City of Boise ADA Assessment

# Appendix A - Fort Boise Community Center

Report #TO20-B012

Facility: Fort Boise Community Center

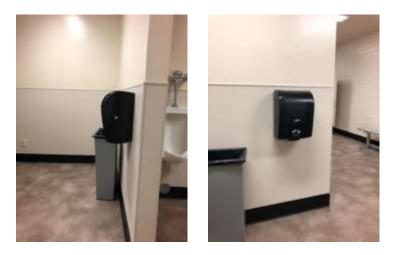
The paper towel dispenser protrudes 9" into the circulation space at 33" above the floor.

Recess the paper towel dispenser so it protrudes a maximum of 4" or place a cane detectable object beneath it.

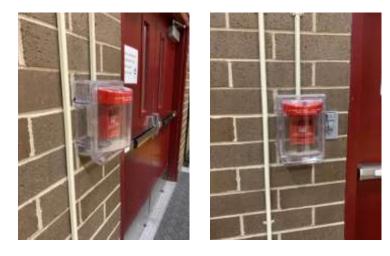
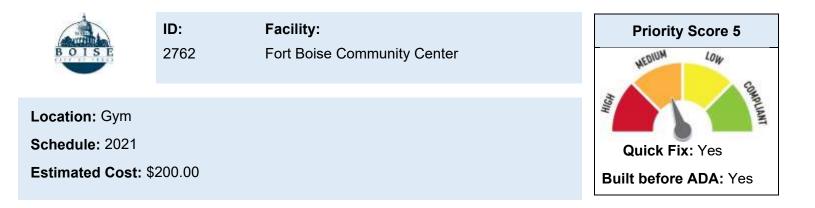
The fire alarm protrudes into the circulation space.

Recess the fire alarm so it protrudes a maximum of 4" or place a cane detectable object beneath it.

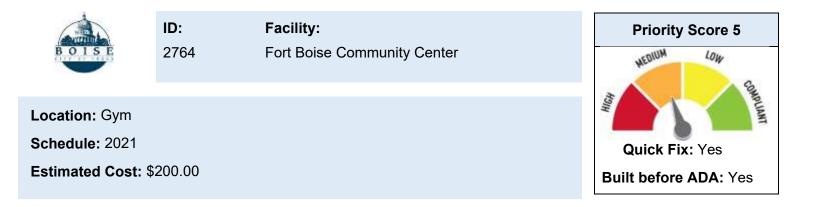
The fire alarm and light switches protrude 5" and 6" into the circulation space at 46" above the floor.

Recess the fire alarm and light switches so they protrude a maximum of 4" or place a cane detectable object beneath them.

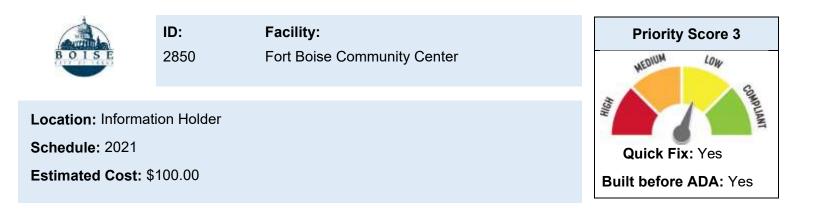
The gym entrance has a 7.8% slope within the doorway's maneuvering clearance.

Reconstruct the entryway's maneuvering clearance to reduce the slope to a maximum of 2% in all directions for the width of the double doors.

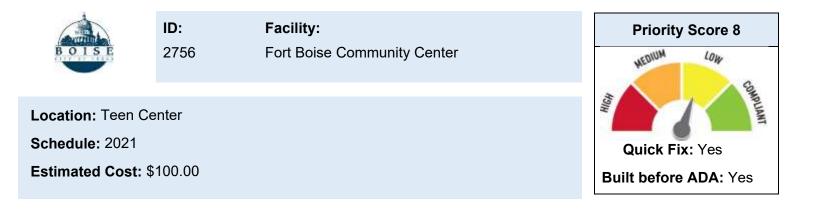
The soap dispenser is outside of the obstructed forward reach range at 52" above the floor.

Lower the soap dispenser by 4" to meet the accessible reach range of 15" minimum and 48" maximum above the floor.

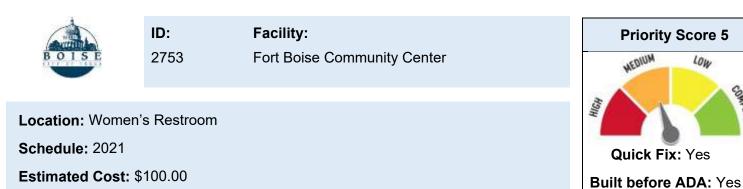
The toilet paper dispenser is located out of the accessible reach range.

Remount the toilet paper dispenser to 7" minimum and 9" maximum in front of the water closet measured to the centerline of the dispenser.

The outlet of the dispenser shall be 15" minimum and 48" maximum above the floor and shall not be located behind.

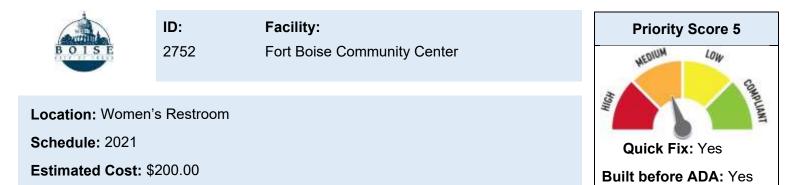
The paper towel dispensers protrude 8" into the circulation space at 53.5" and 57.5" above the floor.
